Access Compliance Report Public Rights-of-Way (Curb Ramps)

Main Street: HEWES_ST	Cross Street: PEARL_ST	Location: NE
-----------------------	------------------------	--------------

ADA ID: RPAT210929095836	Ramp Type: Type 4 - Parallel	Initial Pass/Fail: Fail	Overall Compliance: No	Severity Score: 15
--------------------------	------------------------------	-------------------------	------------------------	--------------------

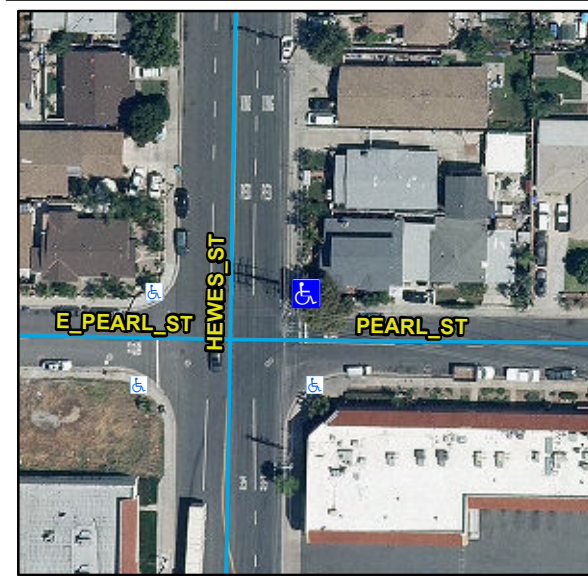
R304.3.2, R302.3, R402.2, STD 1115

Remove & Replace Curb Ramp With Two New Directional Ramps or Equivalent.
